**I. Independent Review of Selected Sections of the
2009 West Valley Decommissioning Final
Environmental Impact Statement**

for the
New York State Energy Research and Development Authority
November 20, 2009

**II. Independent Review of the Draft Environmental
Impact Statement for Decommissioning and/or
Long-Term Stewardship at the West Valley
Demonstration Project and Western New York
Nuclear Service Center**

for the
New York State Energy Research and Development Authority
September 3, 2008

Figure 4 (Figure 2-27 from Sitewide report) WMA 7 Cap and Barrier Wall

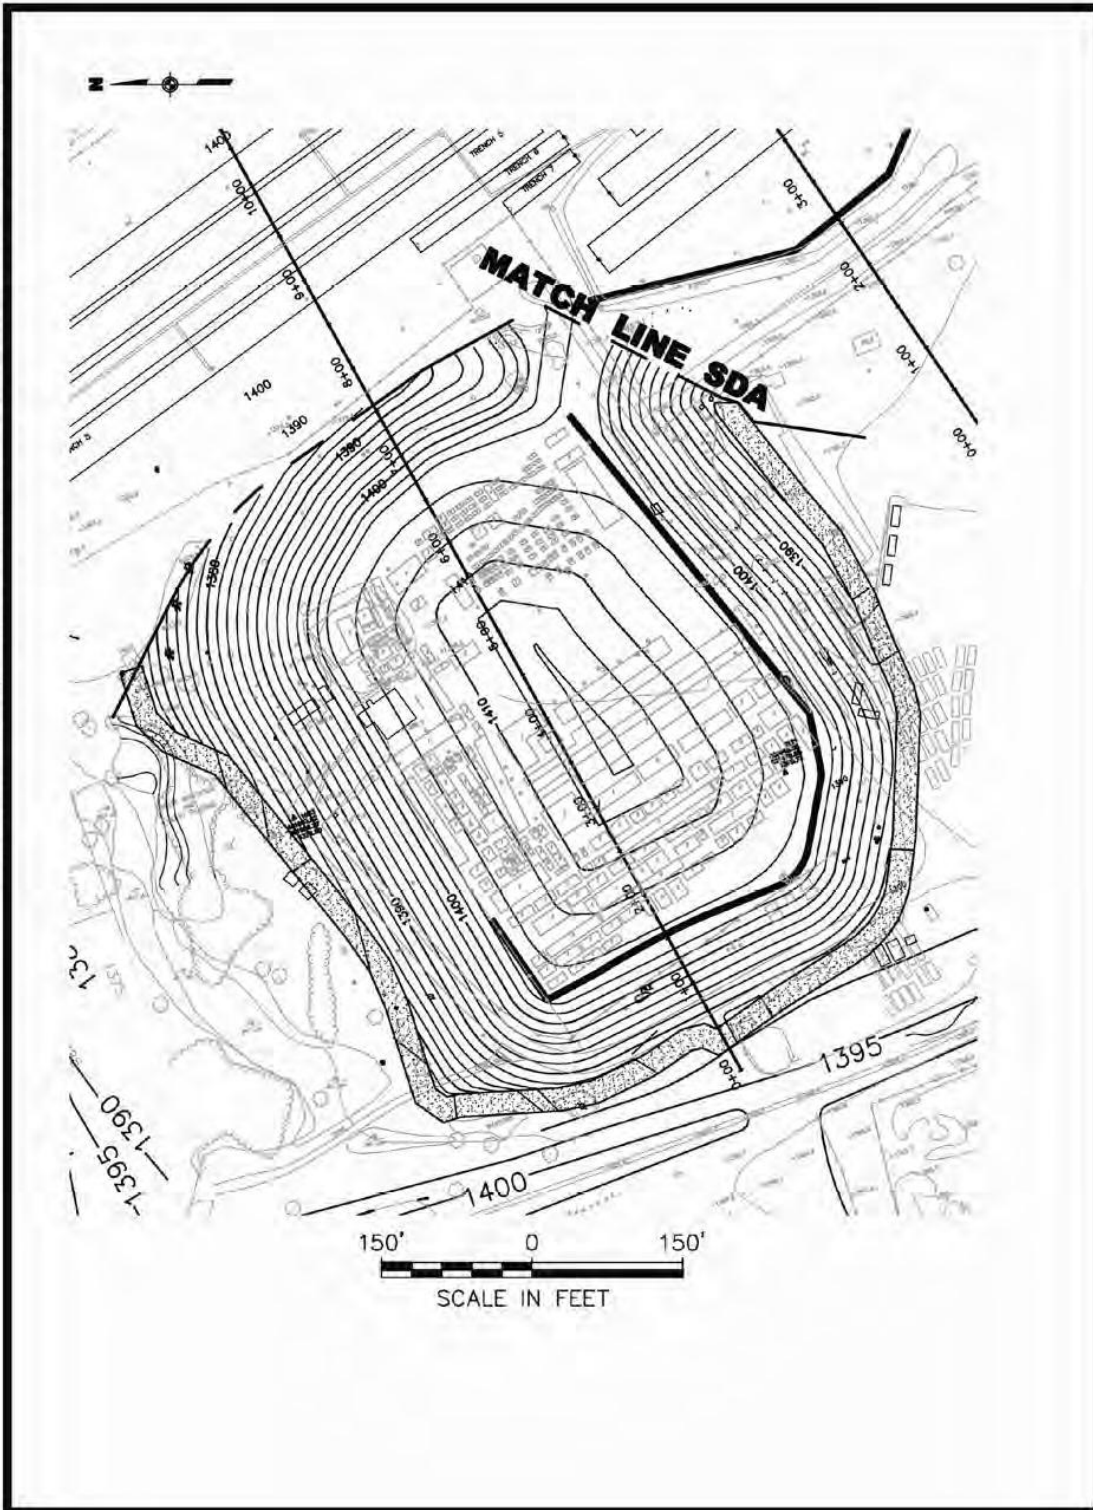
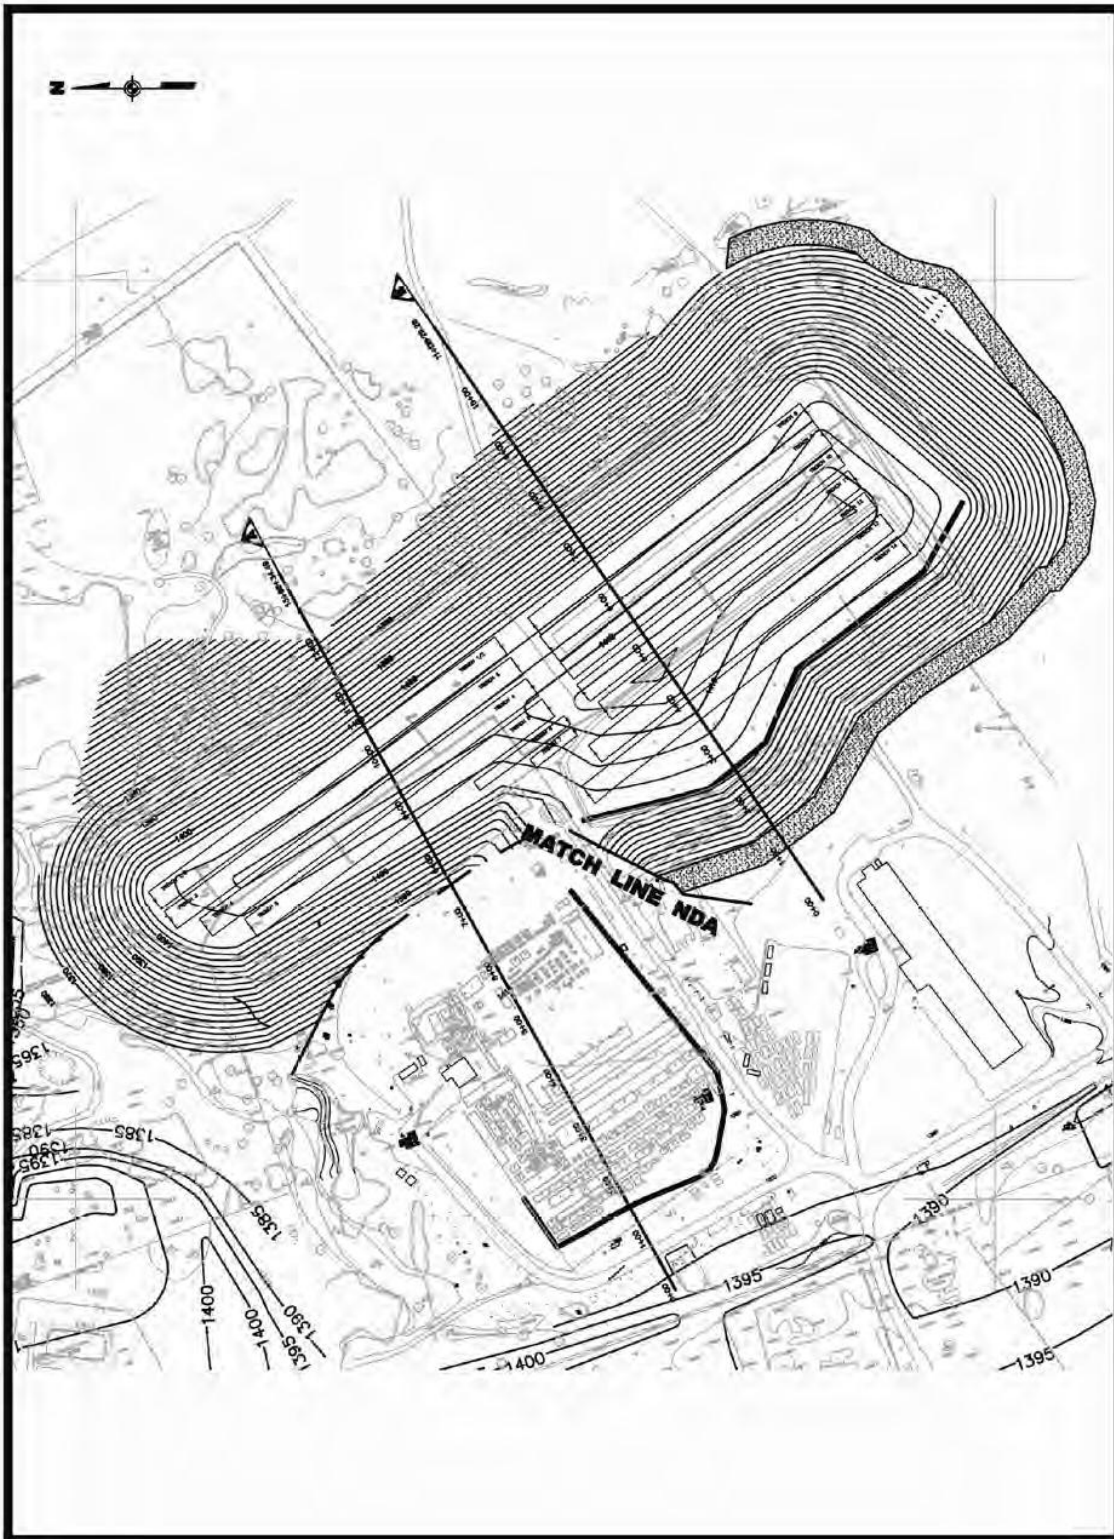
The NDA and SDA are described together because the approach to these areas is similar. The plan is for the trenches and disposal holes in the NDA and SDA trenches to be grouted, covered with geomembrane caps, and surrounded by slurry walls. Figures 4 and 5 illustrate the closure plan.

Figure 6 (Figure 2-36 from Sitewide report) Conceptual Plan for Site-wide Erosion Controls

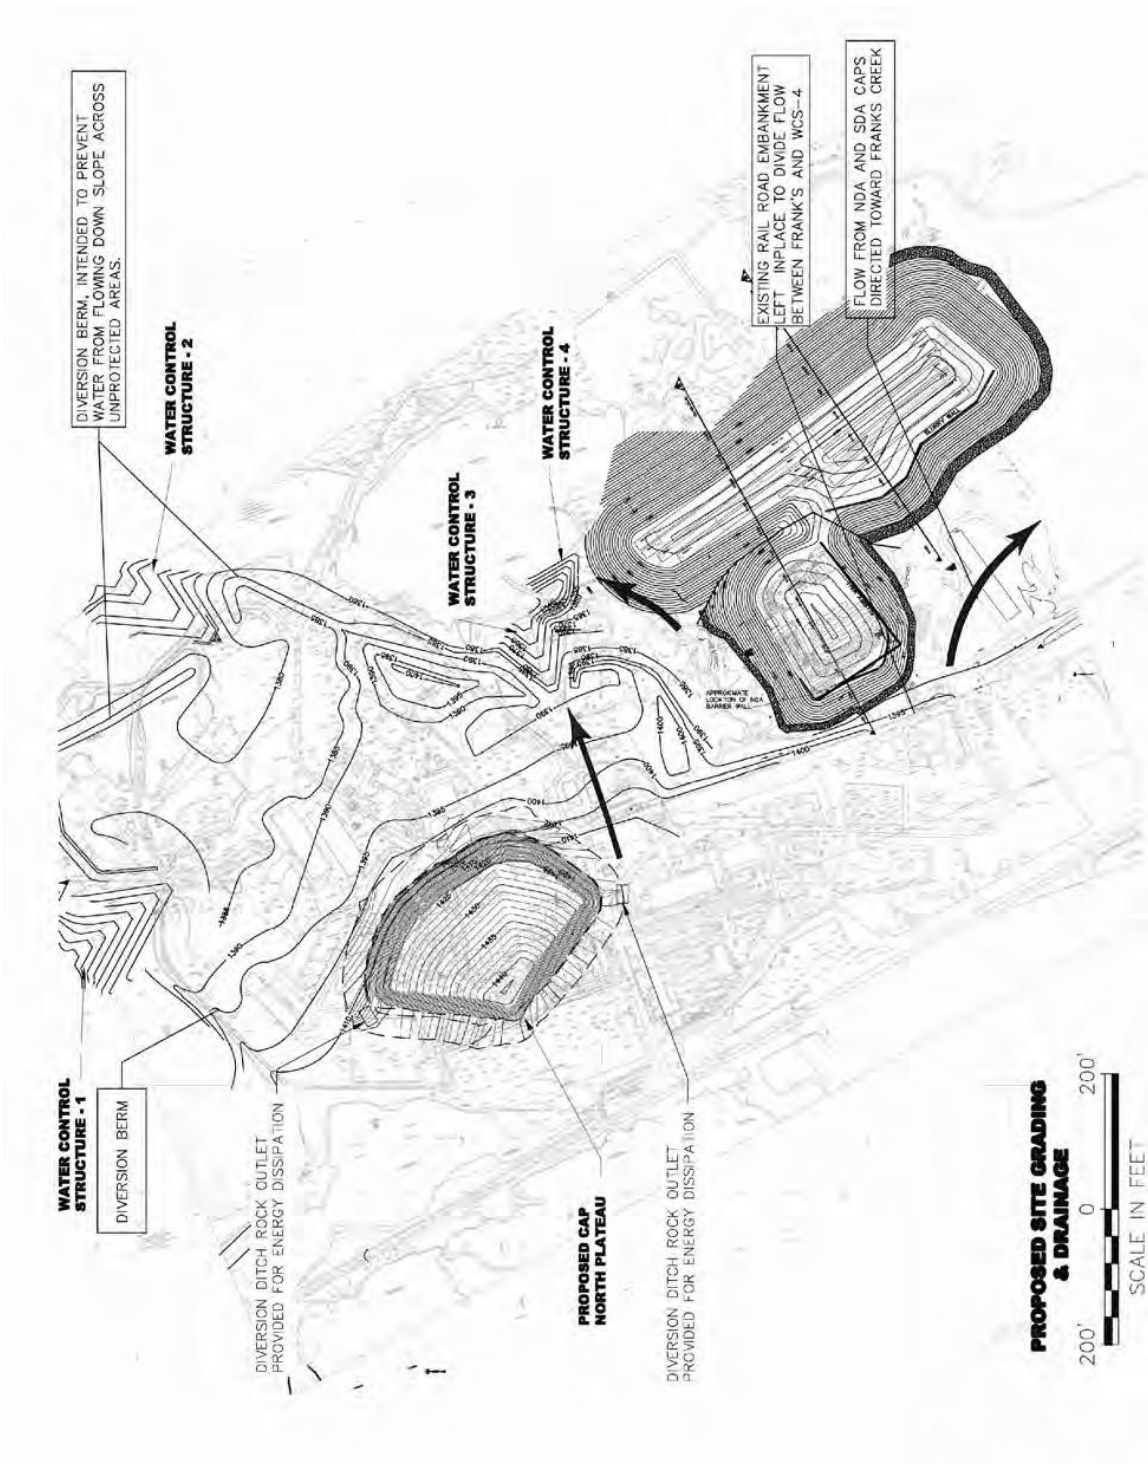
The conceptual long-term erosion control plan is illustrated in Figure 6. This erosion control concept includes:

The primary purpose of installing diversion berms is to control runoff on the North and South Plateaus, and direct the flow to the areas that are appropriately protected against erosion. Diversion berms are intended to mitigate the free flow of runoff over the edge of the plateaus in unprotected areas. The diversion berms running along the top of the Quarry Creek and Franks Creek banks would direct flow to Water Control Structure 1 (WCS1) and WCS2 indicated in Figure 6.

be installed are the NP1 Gully, NP2 Gully, Lagoon Creek Gully, SDA Gully, and (possibly) the NDA Gully (see Figure 6).

Figure 3-5. Environmental Airborne Releases by Implementation Year

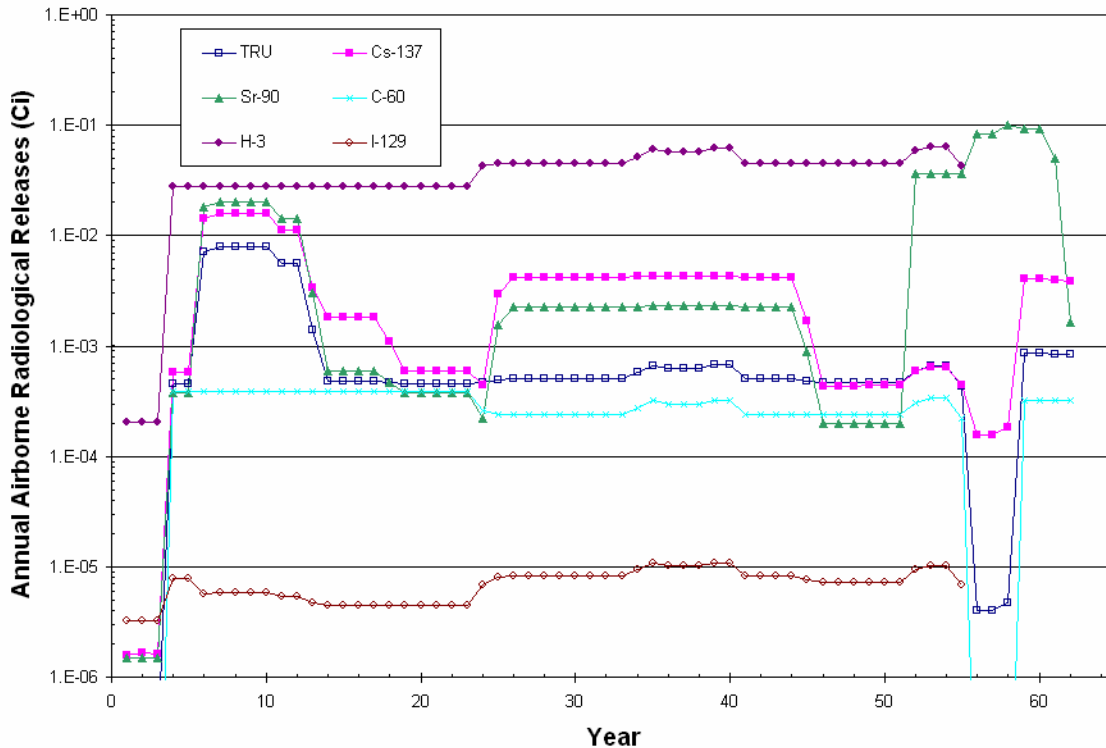
The wisdom of double containment for complete sites is questionable since the atmospheric releases are only 0.1 curies per year of tritium and barely 0.01 of other nuclides are being released to the atmosphere. After 50 years Sr-90 spikes (no explanation is given for that figure except that it involves the removal of the North Plateau Groundwater Plume but does not say what preventive measures such as wetting the soils and noting that strontium does not volatilize) but is still less than 0.1 curies per year. (Figure 3-5 of the STRA.)

Figure 2-28. Conceptual NDA Environmental Enclosure

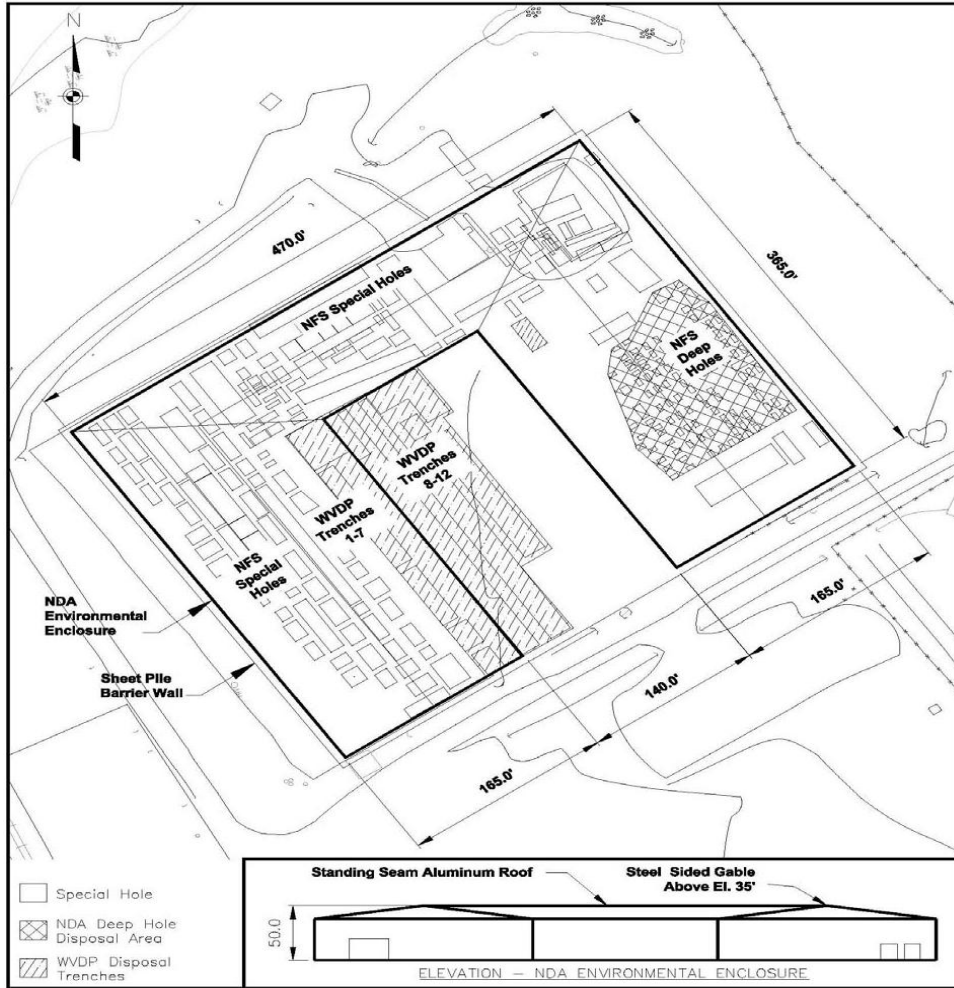
The exact dimensions of the Modular Shielded Environmental Enclosure are unclear as the Perspective View has no dimensions and the Wall and Panel Sections do not show all of the measurements. It is surprising that these structures will not be reused at the SDA but will be demolished at the conclusion of activities.
